# South Bay Connect Project Final Environmental Impact Report

**November 2024**

**Table 3. Matrix of Comment Responses and Changes Made to Draft EIR Text**

Figure 3.18-4: Bicycle Facilities within the Transportation Resource Study Area (Southern Extent)

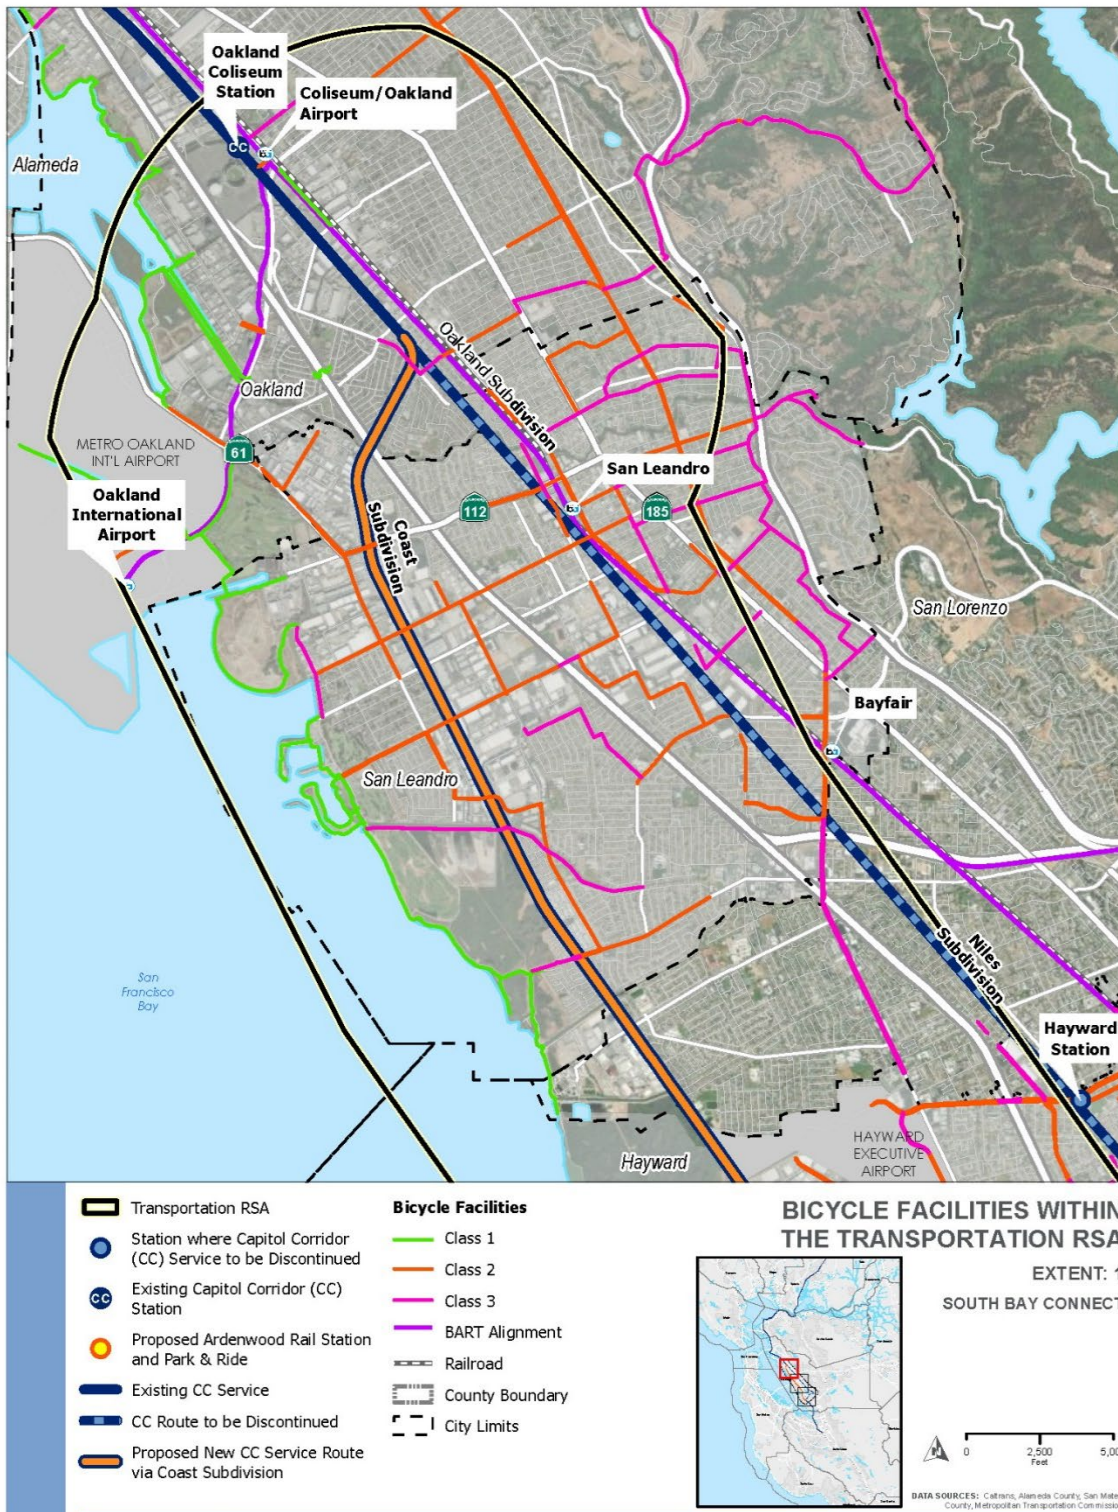
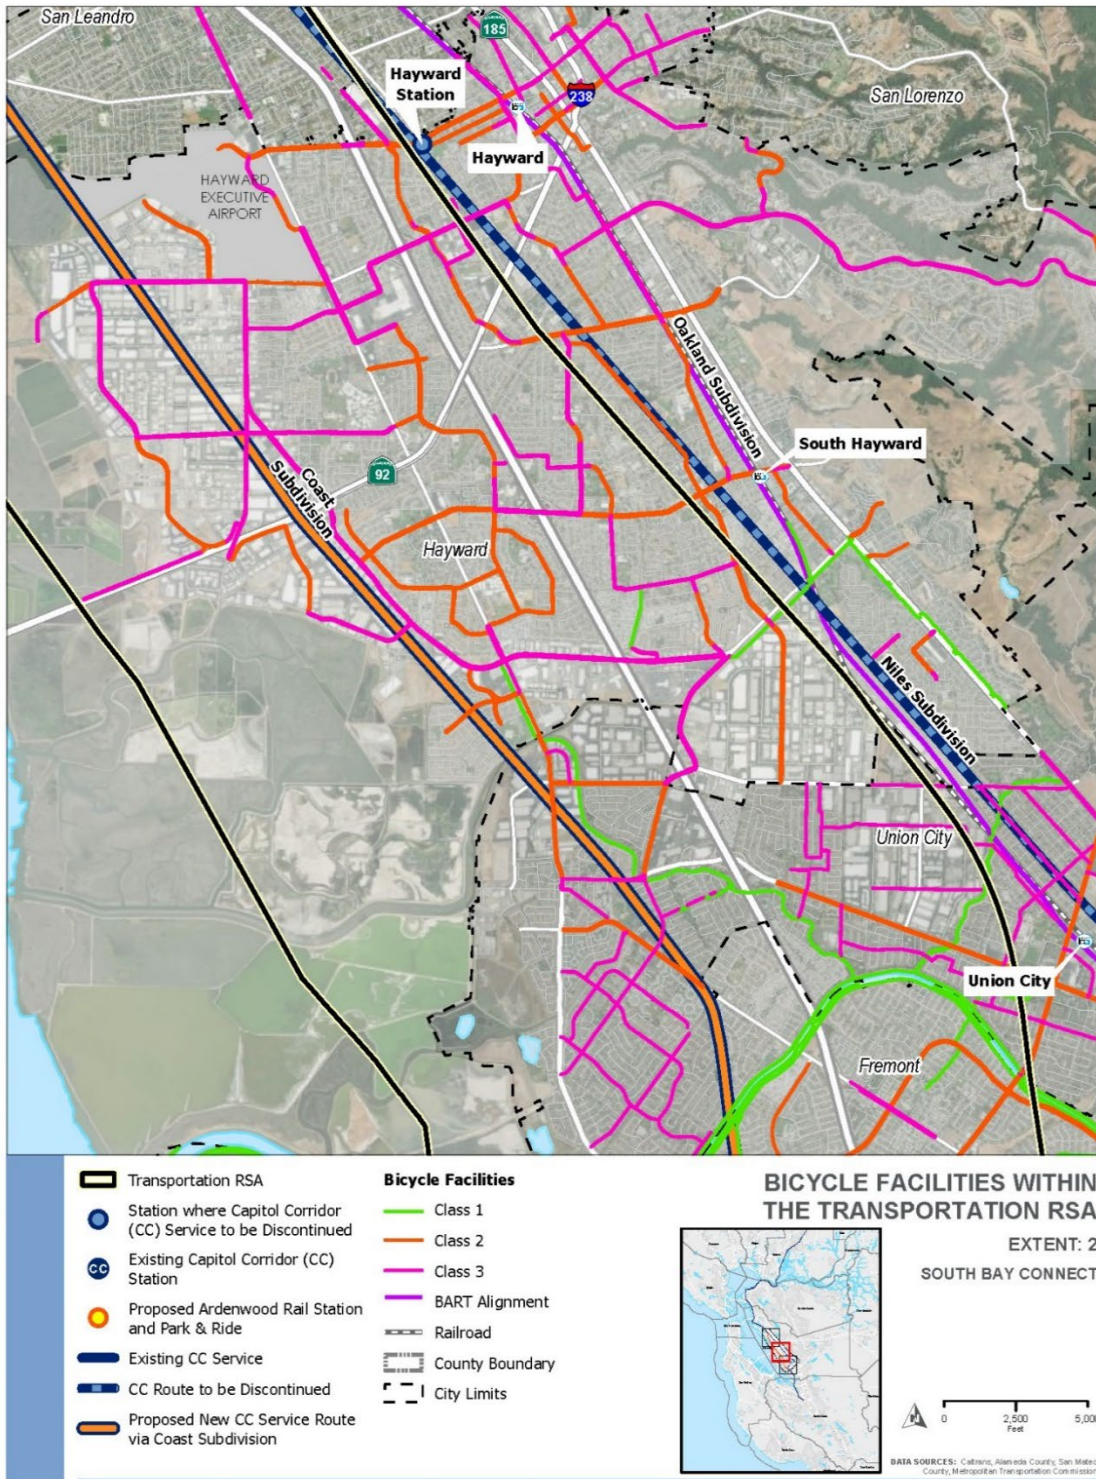
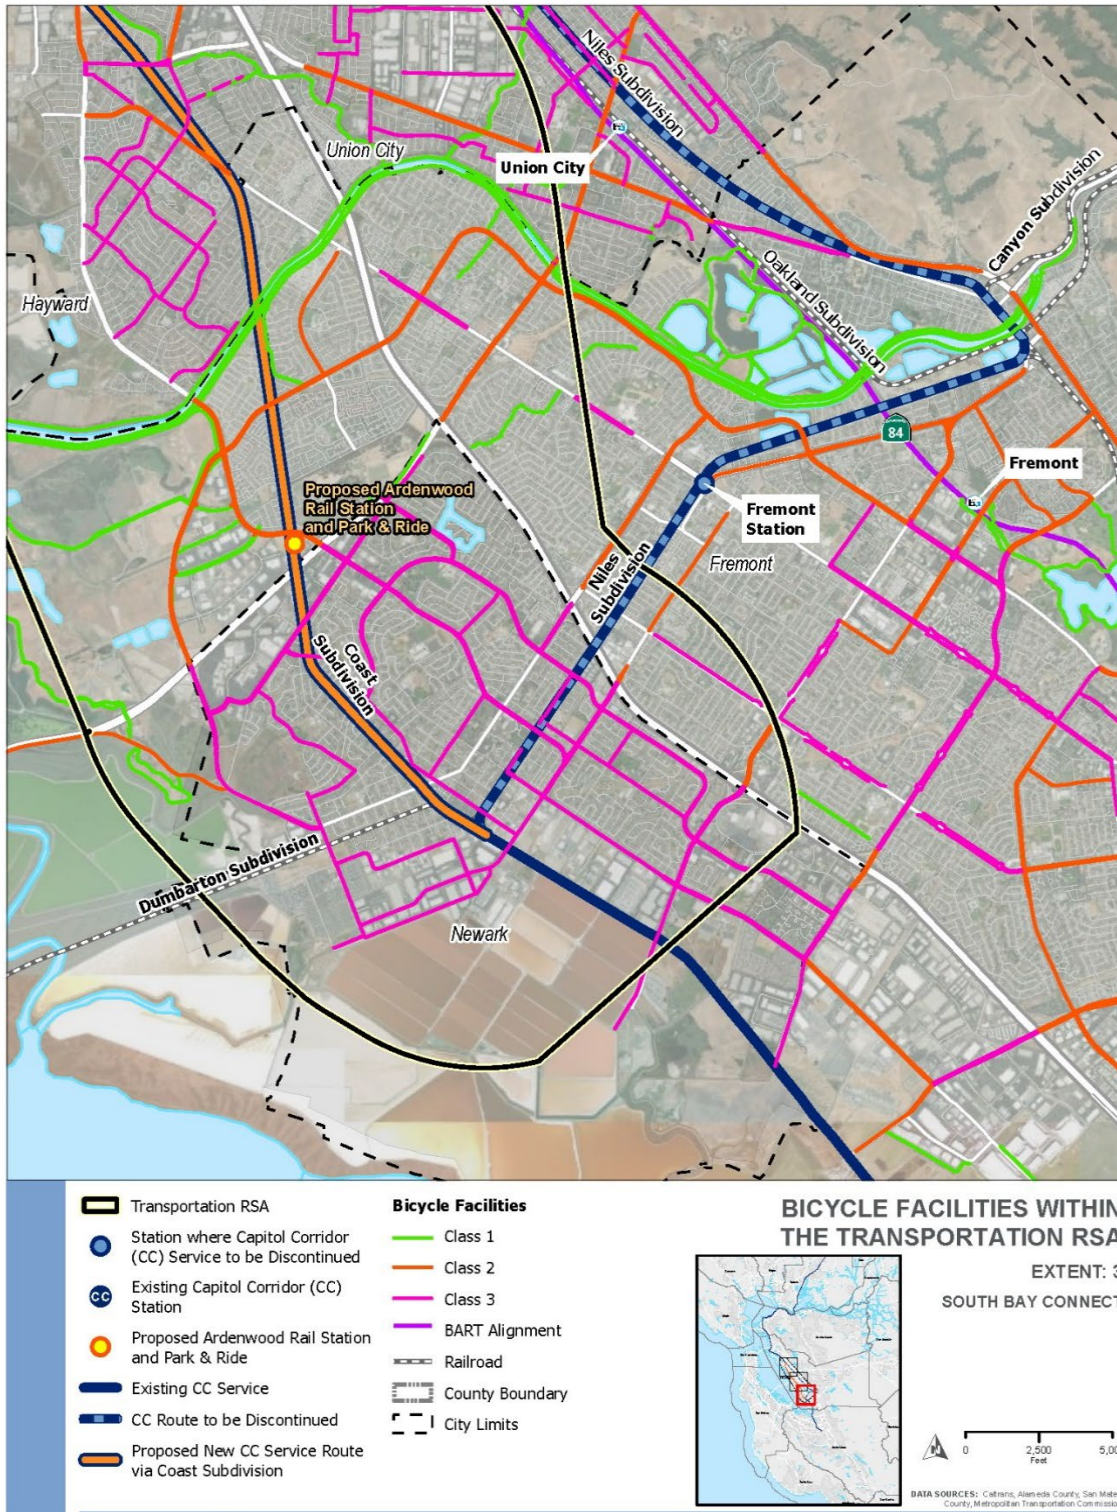
233	23	Comment: The Draft EIR identifies existing pedestrian facilities and Class I, II, and III bicycle routes within the RSA. According to Figure 3.18-4, the City of Newark has mostly Class III routes and some Class I and II routes within the RSA, and a single Class III route would provide access to the proposed Ardenwood Station via Newark Boulevard. Figure 3.18-4 incorrectly classifies most of the City of Newark's Class II routes to Class III routes. Figure 3.18-4 and associated text needs to be revised to correct the bicycle routes in the City of Newark.	Thank you for this clarification. This figure from the DEIR have been updated to reflect your feedback in the Final EIR.	-	The updated Figure 3.18-4 can be reviewed in the Final EIR, Section 4.1.2 which follows this Table 3.
233	24	Comment: Due to its proximity to the City of Newark, the proposed Ardenwood Station could allow for increased ridership to members of the community who rely on walking and cycling for transportation. The 2017 City of Newark Pedestrian and Bicycle Master Plan identifies the Ardenwood Park area as an unsafe, difficult to reach destination via bicycle and walking due to the SR 84 interchange. Since the Ardenwood Station is proposed on the side of SR 84 within the City of Fremont, the Newark community may face challenges accessing the proposed station	Users of the proposed Ardenwood Station could arrive there via driving, riding bus/private shuttle services, biking, walking, or rideshare. There are existing bike lanes and sidewalks along Ardenwood Boulevard/Newark Boulevard for bicyclists and pedestrians to access the existing Ardenwood Park & Ride, as well as the proposed Ardenwood Station.  The City of Newark's Pedestrian and Bicycle Master Plan was	-	-

Updated Figure for Comment Letter 233-23

Figure 4-5. Estimated BCDC Jurisdiction, Extent 5

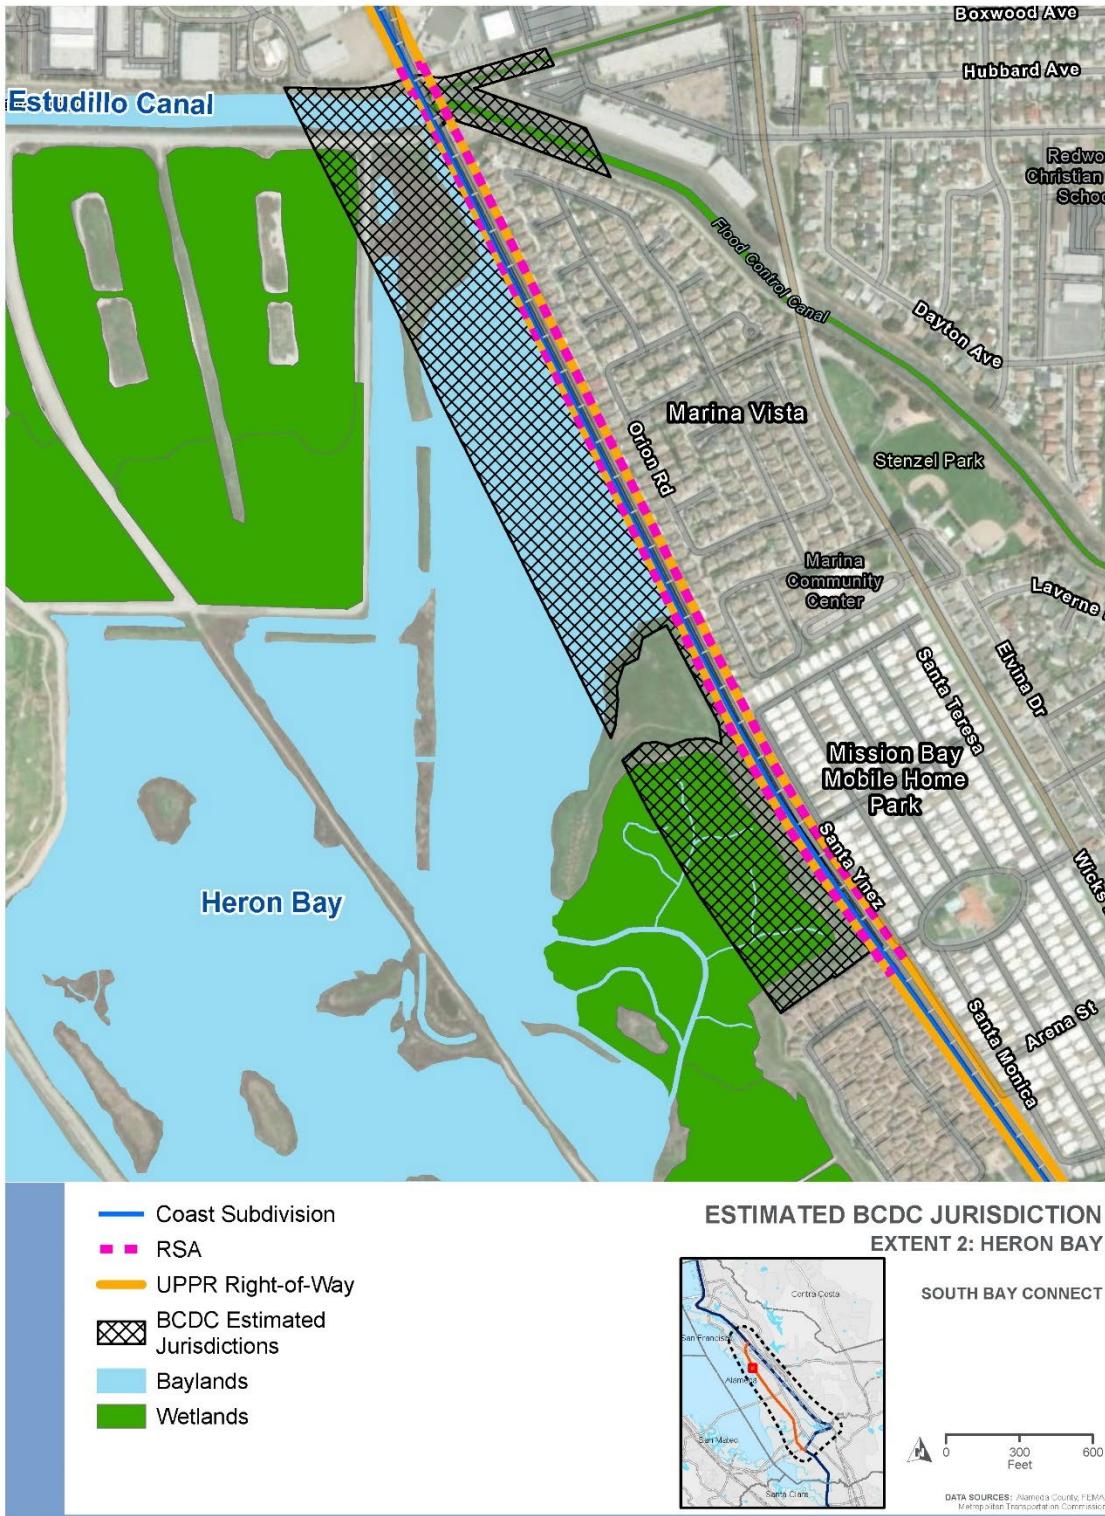
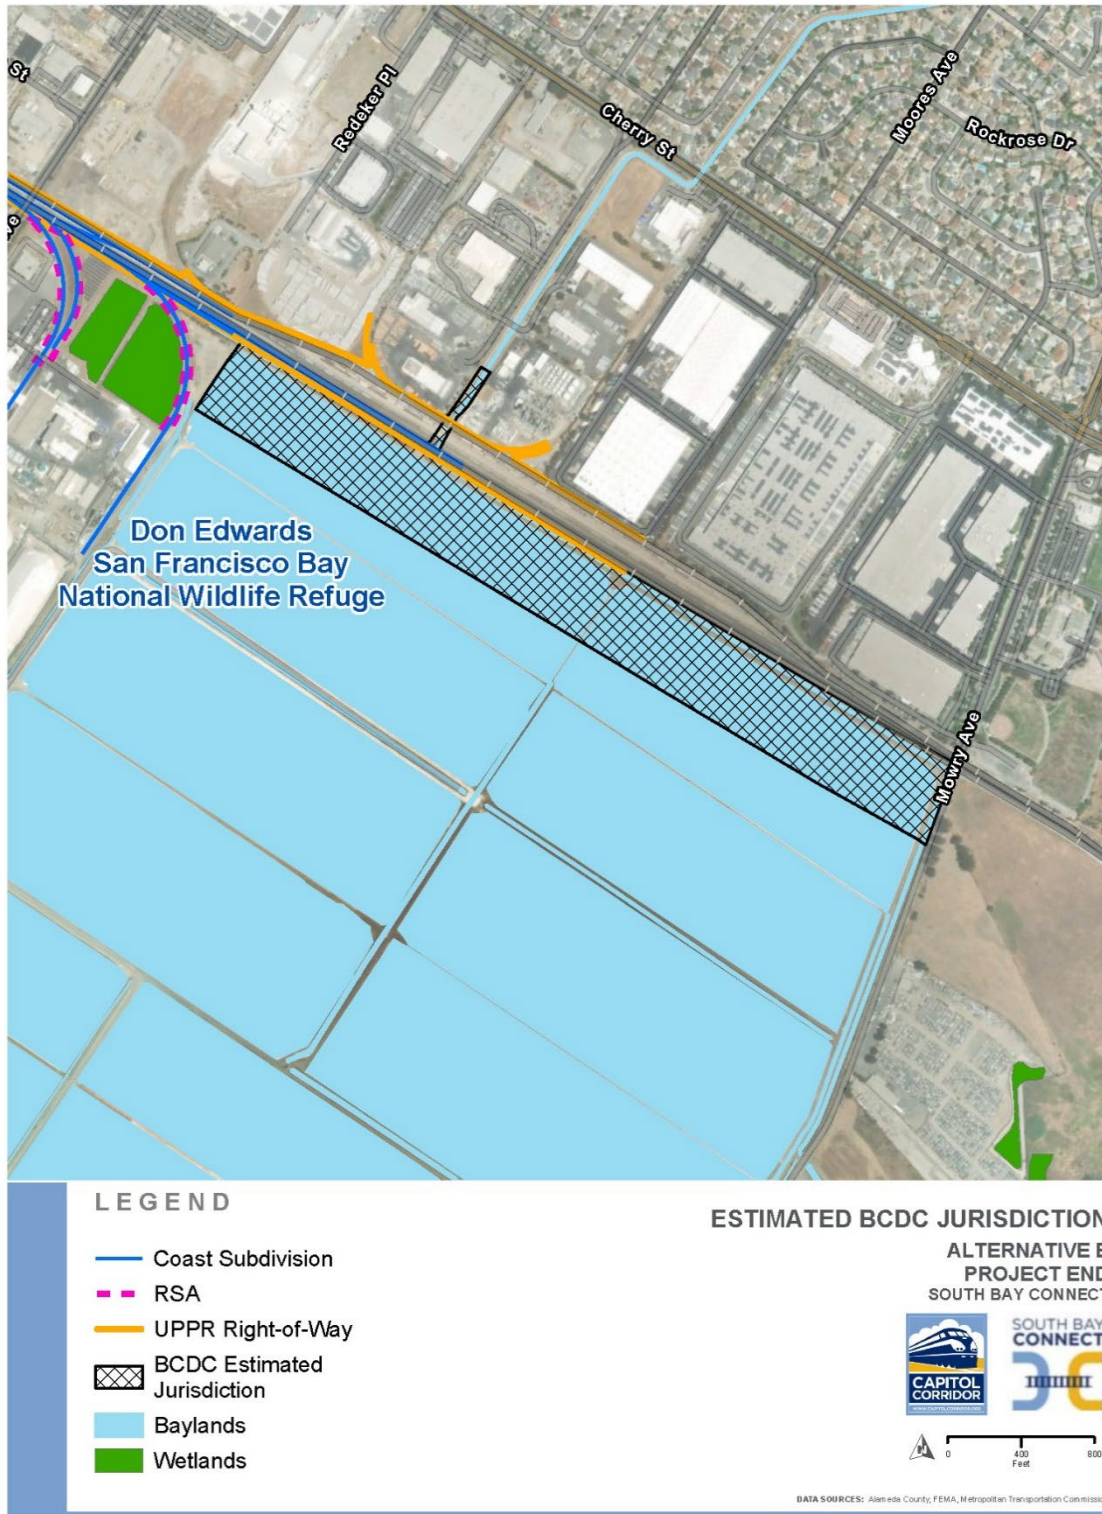
235	21	Page 4-9 – Figure 4-5. Estimated BCDC Jurisdiction, Extent 5 – This figure should identify the Eden Landing Ecological Reserve.	Thank you for your comment. The Eden Landing Ecological Reserve is identified on Page 4-9 in Figure 4-5. No changes to the Draft EIR are required.	-	-
235	22	Page 4-11 - Figure 4-7. Estimated BCDC Jurisdiction, Extent 7: This figure should identify the Don Edwards San Francisco Bay National Wildlife Refuge.	Thank you for your comment. Figure 4-7 on page 4-11 has been updated as demonstrated in the Final EIR Updated Text column. This revision to the Draft EIR does not change the analysis or conclusions in the Final EIR.	-	Figure 4-7 updated in Final EIR, Section 4.1.2

Updated Figure for Comment Letter 237-2
